**CHANGE NOTICE**

5. Contract No.  NAS15-10000	6. Directive No.	
7. Document No./Rev. SSP 30312 Revision H		8. Document Title Electrical, Electronic, And Electromechanical (EEE) And Mechanical Parts Management And Implementation Plan For Space Station		9. SSCN No. SSCN 005645

10. Related Change No.		11. Change Title Exceptions To SSP 30312 Revision H			
THIS NOTICE INFORMS RECIPIENTS THAT THE DOCUMENT IDENTIFIED BY THE NUMBER (AND REVISION LETTER) SHOWN IN BLOCK 7 HAS BEEN CHANGED. THE PAGES CHANGED BY THE CN BEING THOSE FURNISHED HERE WITH AND CARRYING THE SAME DATE AS THIS CN. THE PAGES OF THE PAGE NUMBERS AND DATES LISTED BELOW IN THE SUMMARY OF CHANGED PAGES COMBINED WITH NON-LISTED PAGES OF THE ORIGINAL ISSUE OF THE REVISION SHOWN IN BLOCK 7 CONSTITUTE THE CURRENT VERSION OF THIS SPECIFICATION.

Exception 98 To SSP 30312 Requirements (continued)  
Attachment 1 - J1 Umbilical Cables

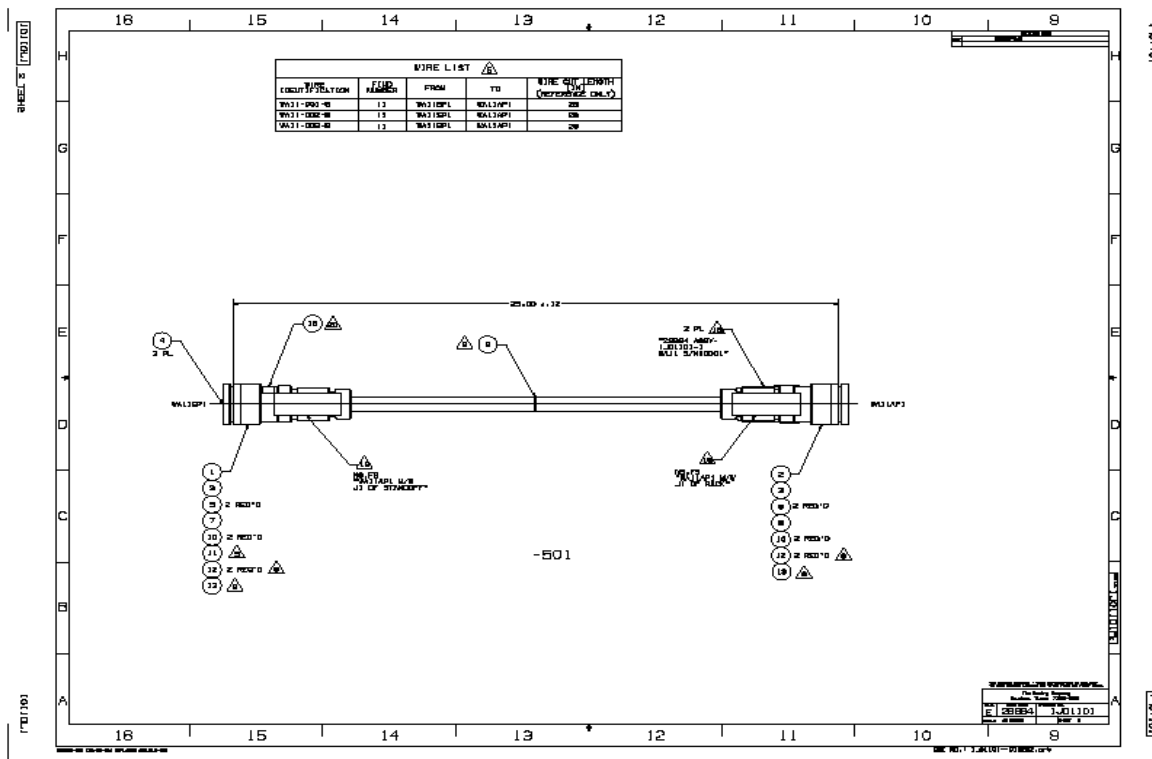
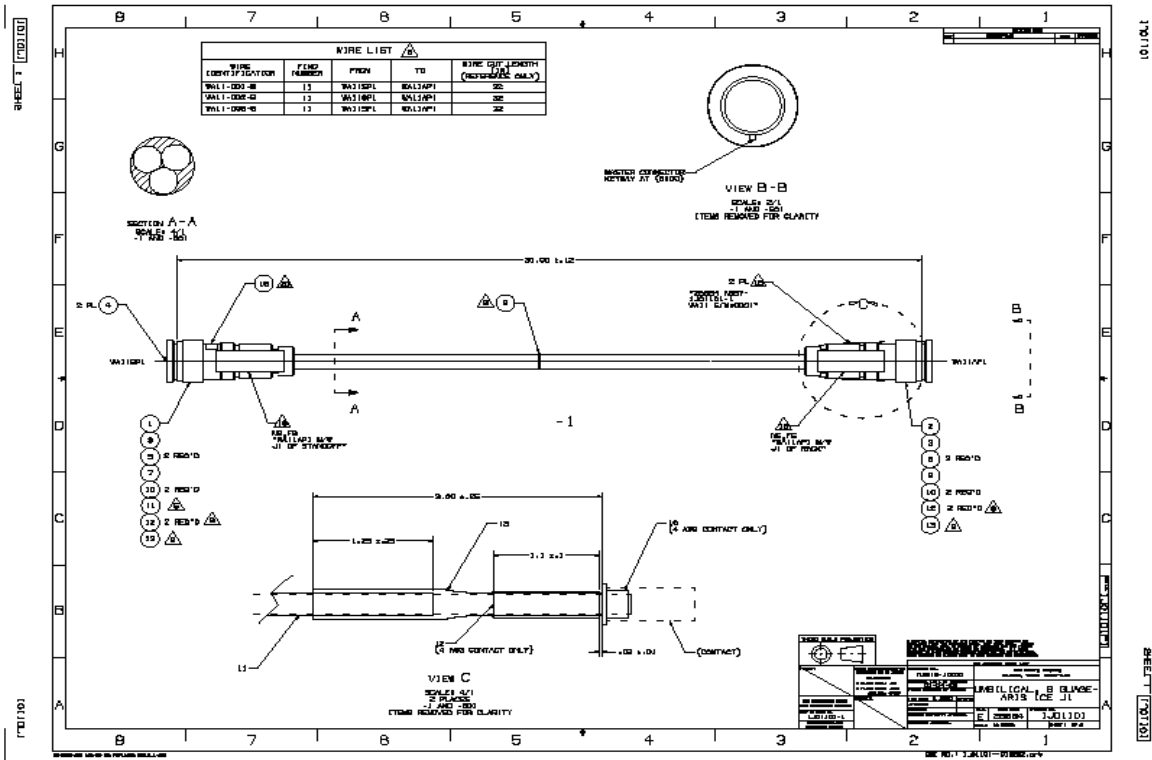
The maximum temperature for the ISS is defined as 46°C (115°F) with a nominal range of 17 to 28°C (63-82°F). Based on the maximum defined temperature of 46°C and the wire insulation rated at 200°C, the maximum allowable delta T for the ARIS J1/J2 umbilical is 154°C (309°F). Based on the 102179, Figure 3 - single wire in free air, the delta T for an 8-gauge wire at 55Amp is 25°F. This value falls below the maximum allowable delta T of 309°F. In the unlikely event that the rack remains powered at same time the module is unpressurized the delta T at 55Amp would be ~ 140°F (reference 102179, Figure 5 - single wire in a vacuum at 72°F ambient). This delta T is also below the maximum allowable of 309°F.

Based on SSP57001, Figure 3.2.6-3, the maximum sustained current attainable in the JEM is 65A. This value falls below both the pressurized and vacuum environment current ratings defined in 102179, but exceeds the SSP30312 current ratings. The delta T in a pressurized environment would be 35°F and 180°F in a vacuum environment. The resultant IVA touch temperature at 82°F ambient is 117°F. Based on the current ratings defined in 102179 the ARIS umbilicals are compatible with all ISPR locations in the JEM, however approval for use in the JEM must be coordinated with NASDA.

Based on SSP57001, Figure 3.2.6-1, the maximum sustained current attainable in the APM is 79.6A. This value falls below both the pressurized and vacuum environment current ratings defined in 102179, but exceeds the SSP30312 current ratings. The delta T in a pressurized is 60°F and is 250°F in a vacuum environment. Both of these values fall below the maximum allowable delta T of 390°F.

**Note:** Using Type III RPC to protect 6 kW rack (nominal current of 50 Amps) complies with ISS EPS Architecture requirements. Type III RPC will trip between 55 Amps and 60 Amps if the overcurrent condition persists for more than 40 ms. Type III RPC allows higher transient current for shorter duration, e.g., 95 Amps for transient less than 40 ms. The duration of surge current from the racks will be limited to 10 ms. Therefore, nuisance trips are avoided.
